# PITT ST SOUTH

OVER STATION DEVELOPMENT

RESPONSE TO SUBMISSIONS

SEPTEMBER 2020

Level 06 Terrace\_Proposed\_Plan

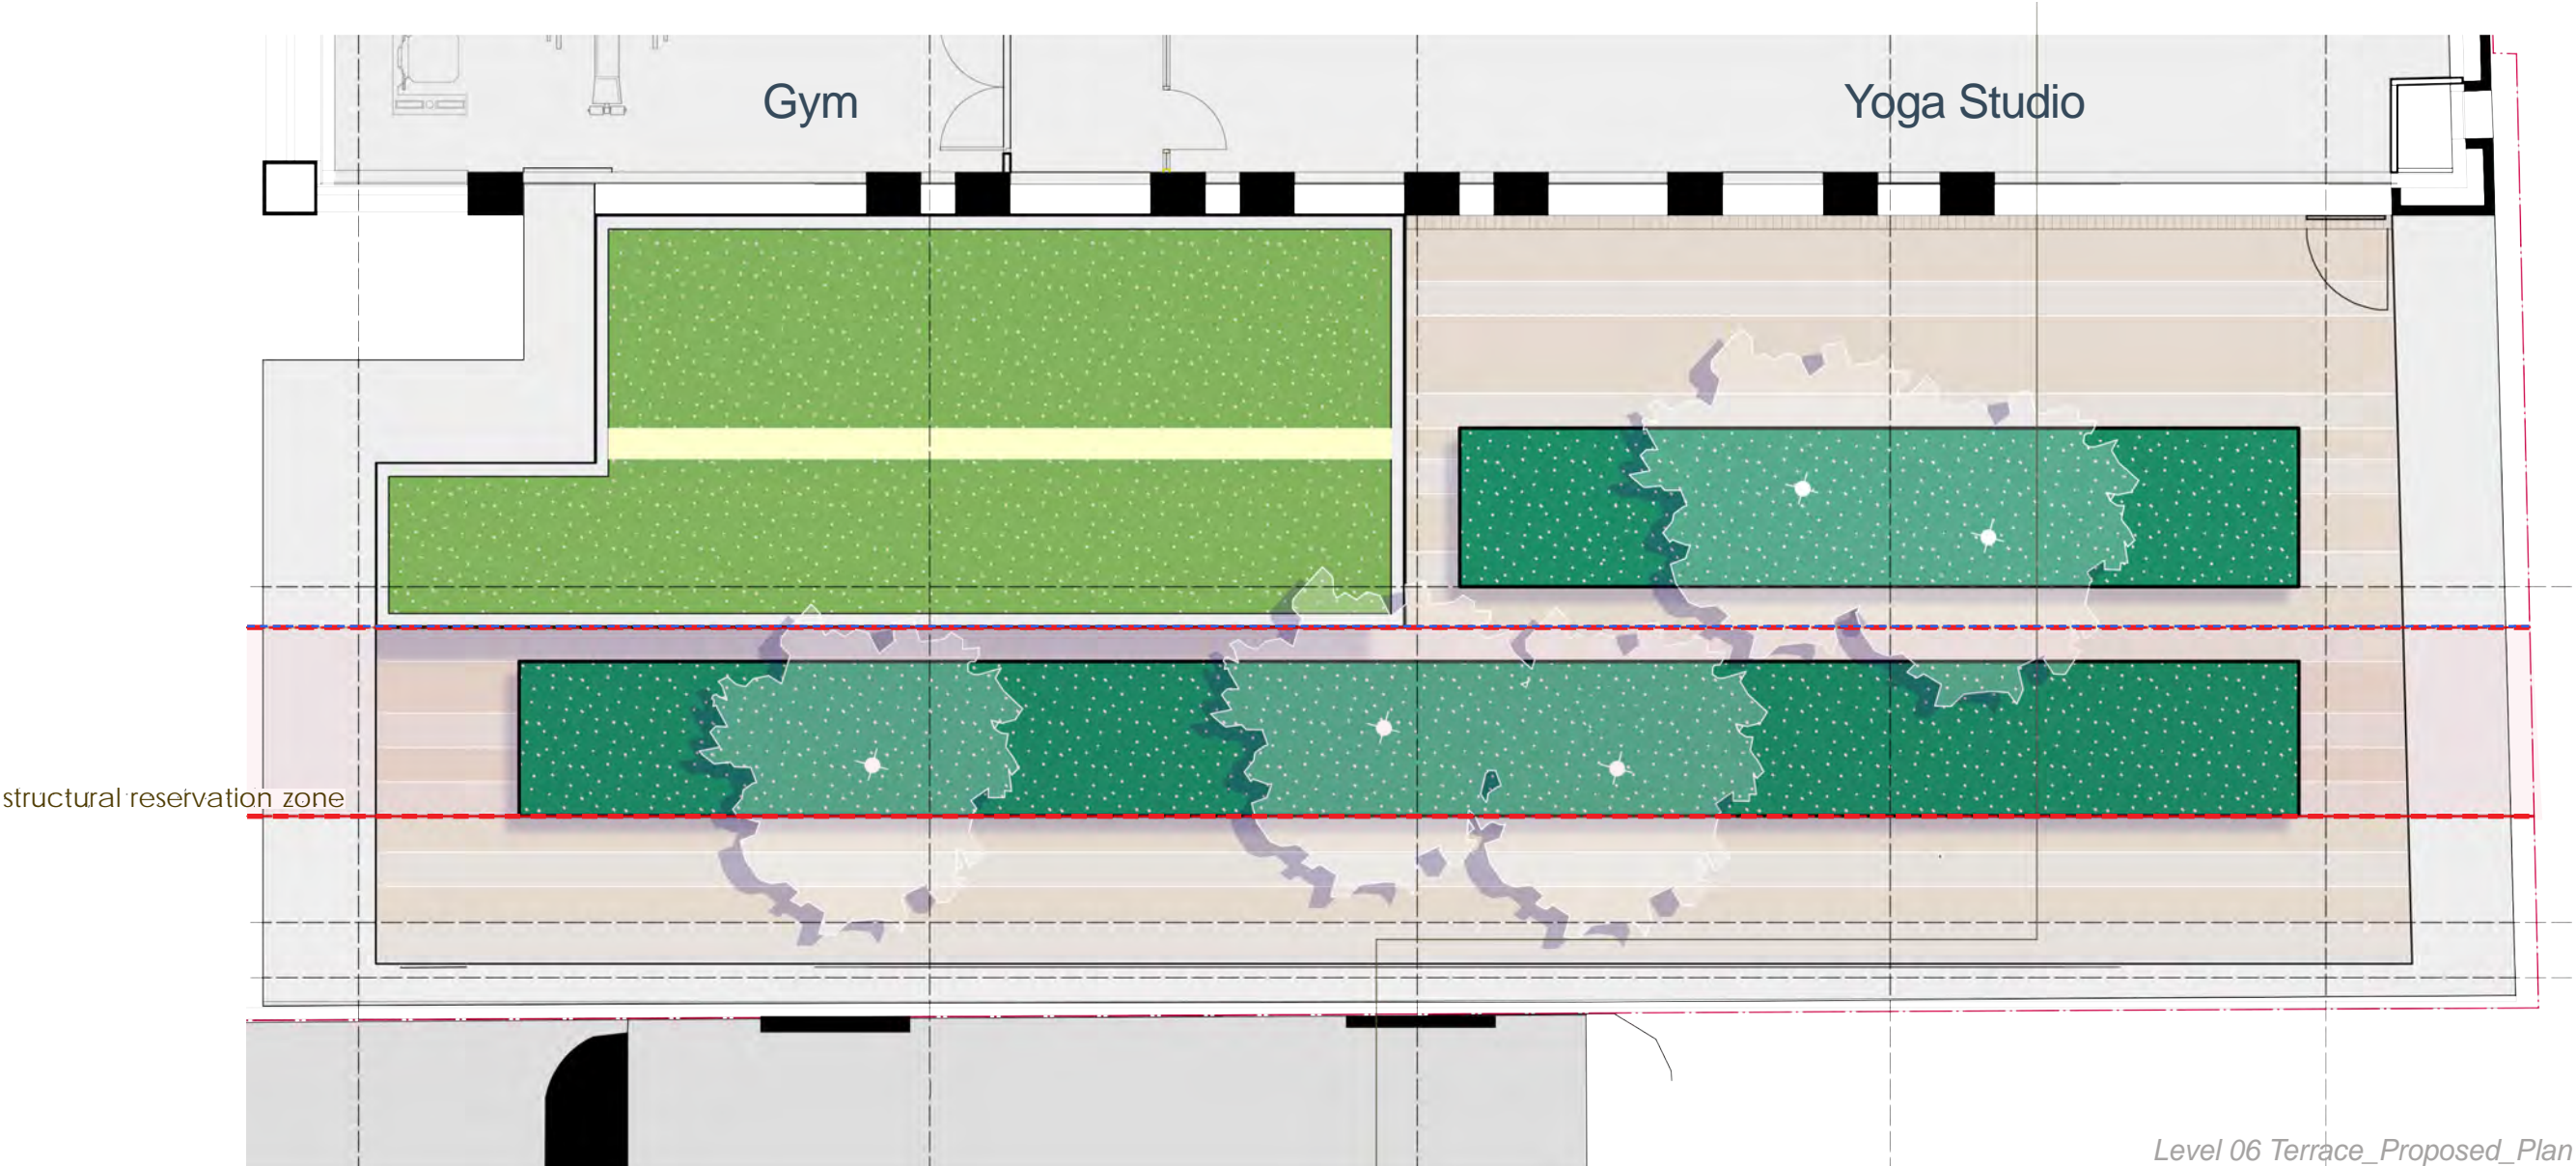
*(d) Demonstrate a reasonable level of privacy and amenity can be maintained between the proposed building and adjoining Princeton Apartments, including further consideration of:*

In response to concerns raised by residents of Princeton Apartments, the Applicant has reviewed their desire for communal open space in this area and wishes to address the neighbour concern by removing resident access to the terrace and making it a non-accessible landscaped terrace only.

- The revised design (adjacent):
- / Removes resident access from the roof terrace and converts it to a non-accessible green roof providing a landscaped outlook only, therefore addressing privacy and acoustic concerns associated with residents potentially being outdoors and in close proximity to windows on the Princeton boundary,

- / Will provide a pleasant landscaped outlook for residents of both buildings
  - / The landscaping is centrally located on the terrace so as to provide equal outlook and screening to both buildings,

- / The plant space has been consolidated to the East into a single volume, and is now wholly contained with the Approved Concept Envelope,
  - / All built form has been removed from the structure reservation zone except for raised planters and trees,

- / Planting has been maximised within the permissible extents of the approved stage 01 envelope.
- For further detail please refer to the accompanying landscape report prepared by Sue Barnsley.

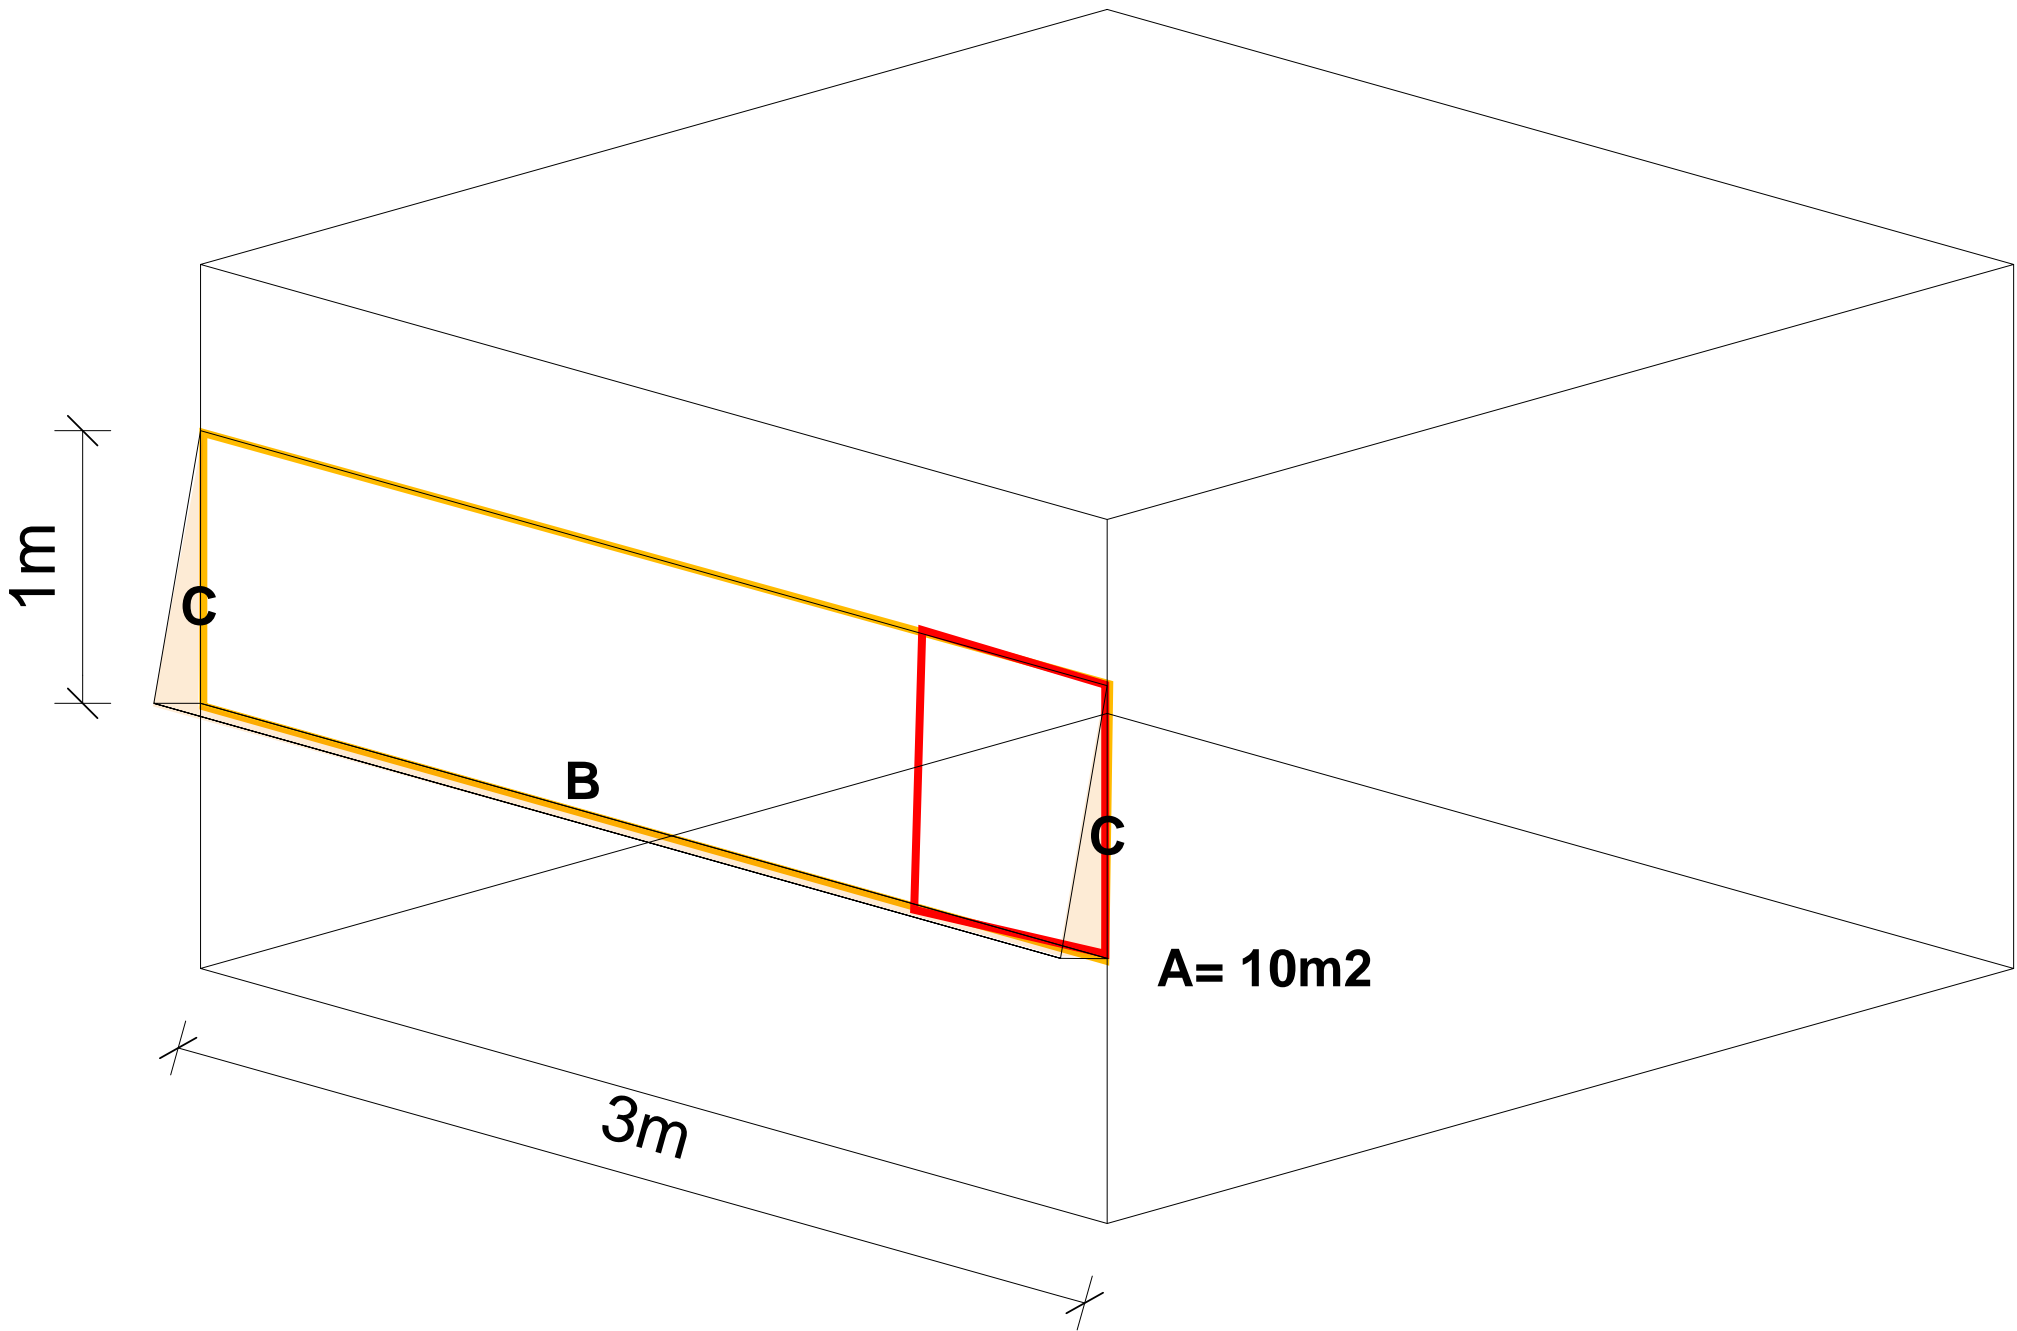
*Review and revise the proposal with respect to compliance with SEPP 65 and the Apartment Design Guidelines (ADG) (as required by Condition B3(h) of the Concept Approval), including further consideration and illustration of:*

BCA natural ventilation criteria requires an opening of minimum 5% of the floor area measured in accordance with figure 2A, resulting in a minimum complying window size of 1m tall by 0.5m wide (shown in red). Ie, a typical window dimension, albeit slightly smaller than could be considered a high amenity outcome.

The ADG Design Guidance also requests 5% of the floor area, but measured in accordance with figure 2B resulting in a **minimum** window size of 3 metres wide x 1m tall (shown in orange) which only barely achieves 5% compliance.

In light of the above, we have designed the proposed operable windows in this development to be 100% compliant with the legally binding instrument, the Building Code of Australia, in terms of both natural ventilation compliance and fall prevention.
